# Access Compliance Report

## Public Rights-of-Way

Intersection ID: 25834	Main Street: PARK_RD	Cross Street: OSPREY_DR	Location: S
ADA ID: 9F9EE1015DFF	Ramp Type: PerpDiag	Initial Pass/Fail: Fail	Overall Compliance: No
			Severity Score: 46.25

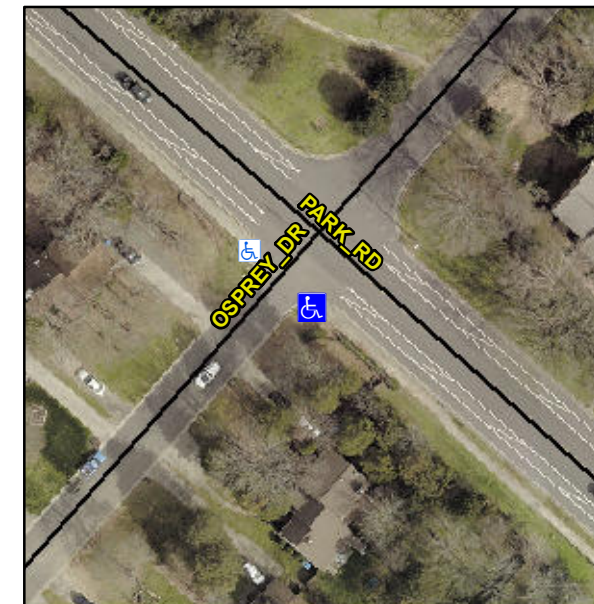
**Not Found, R304.5.1, R304.2.2, R304.5.3**

Compliance	Description	Data	Compliance	Description	Data
N/A	Ramp Length (in)	71.0	No	Ramp Slope (%)	8.7
No	Ramp Width (in)	46.0	No	Ramp XSlope (%)	10.4
N/A	Flare Type LT	N/A	N/A	Flare Type RT	N/A
N/A	Flare Slope LT (%)	N/A	N/A	Flare Slope RT (%)	N/A
N/A	Flare Traversable LT?	N/A	N/A	Flare Traversable RT?	N/A
N/A	Landing Length (in)	N/A	N/A	DWS Provided?	N/A
N/A	Landing Width (in)	N/A	N/A	DWS Contrast?	N/A
N/A	Landing Slope (%)	N/A	N/A	DWS Length (in)	N/A
N/A	Landing X Slope (%)	N/A	N/A	DWS Full Width?	N/A
N/A	Landing Curb? (Y/N)	N/A	N/A	DWS Offset (in)	N/A
N/A	Shared Landing?	N/A			
N/A	Gutter Ponding?	N/A	N/A	Gutter Slope (%)	N/A
N/A	Gutter Lip Ht (in)	N/A	N/A	Gutter X Slope (%)	N/A
N/A	Painted X Walk1?	No	N/A	Painted X Walk2?	No
	X Walk 1 Direction	To NE		X Walk 2 Direction	To NW
N/A	X Walk 1 Width (in)	N/A	N/A	X Walk 2 Width (in)	N/A
	X Walk 1 Slope (%)	0.1		X Walk 2 Slope (%)	5.4
	X Walk 1 X Slope (%)	4.9		X Walk 2 X Slope (%)	4.6

**Remove & Replace Curb Ramp With Two New Directional Ramps or Equivalent.**
